KENYA RURAL ROADS AUTHORITY

ADDENDUM NO. 1

TENDER FOR INSTALLATION, INTEGRATION, MANAGEMENT AND OPERATION OF VIRTUAL WEIGHBRIDGE STATIONS

TENDER NO. KeRRA/08/39/81/2023 - 2024

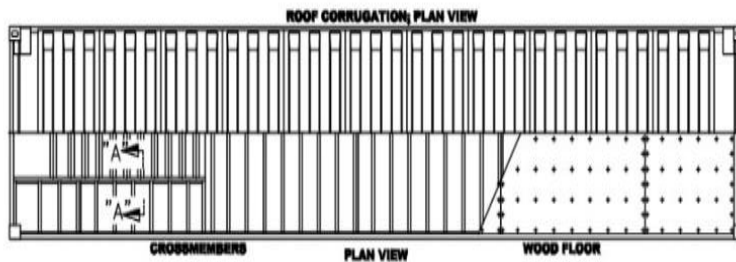
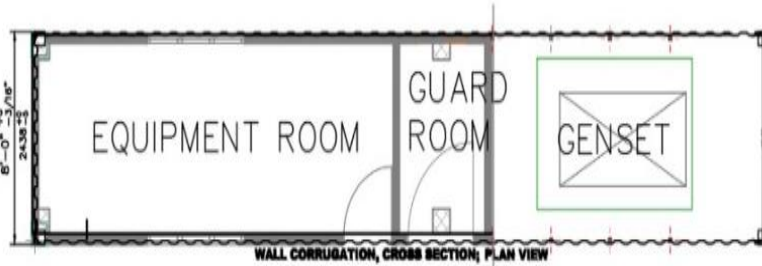
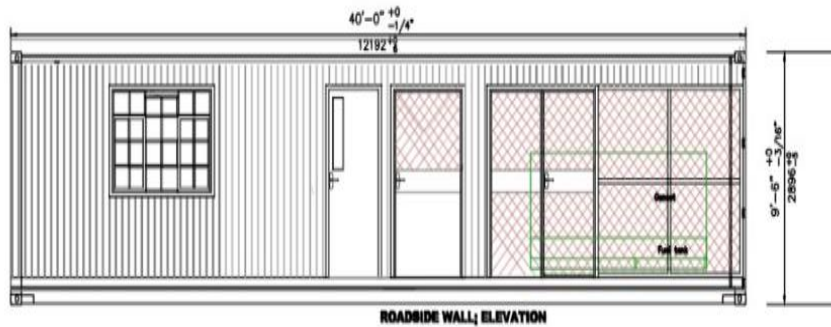
2	<ul style="list-style-type: none"> Clarification: At Ngong-Suswa station, there is no KPLC power connection line nearby, and the option is to install a transformer or substation, which is extremely costly. Do we still proceed with the cost for a transformer, or do we leave this station out of this bill? Can we propose alternative power solutions like solar, and if yes, what would be the specifications so that all bidders are on the same page on what to cost? 	<ul style="list-style-type: none"> Please exclude Ngong - Suswa from the grid power connection and provide costing for a solar solution that can adequately power the station. (At least 20 KVA) The grid power connection requirements for the rest of 3 stations have not changed and the bidder is required to provide costing for connecting to the grid power supply.
